RENDERING EAST FACADE
25 M STREET SE

APPROVED PLAN
Ground Level

REVISED PLAN
Ground Level

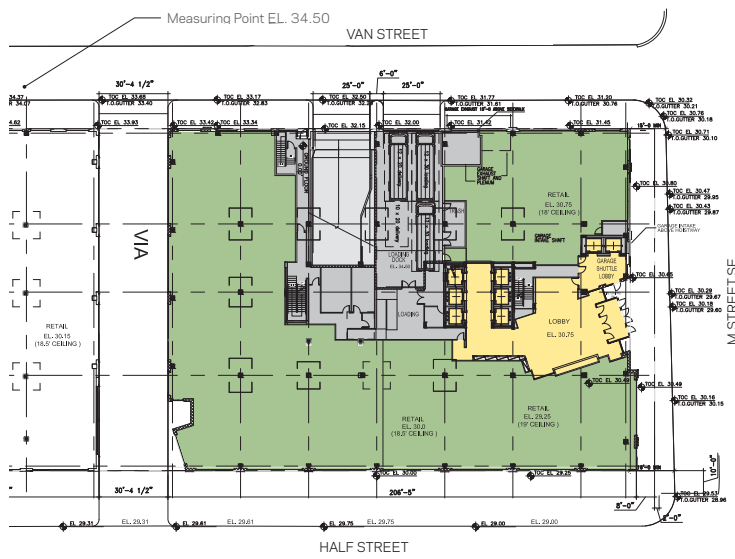
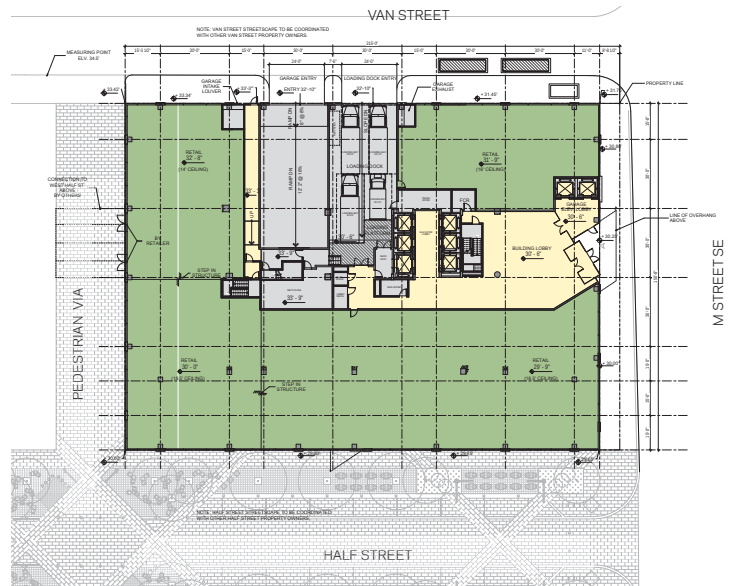
- New location of garage intake will break the **continuity of retail space** and disrupt pedestrian experience in both via and van street.
- **Depth of retail space** at corner of Via and Van street will reduce drastically. not a proper portion.
- **Additional service corridor** for retail units required which reduces ground floor retail area.
- New location we are **losing 10 parking spaces** which necessitates an additional level of parking.
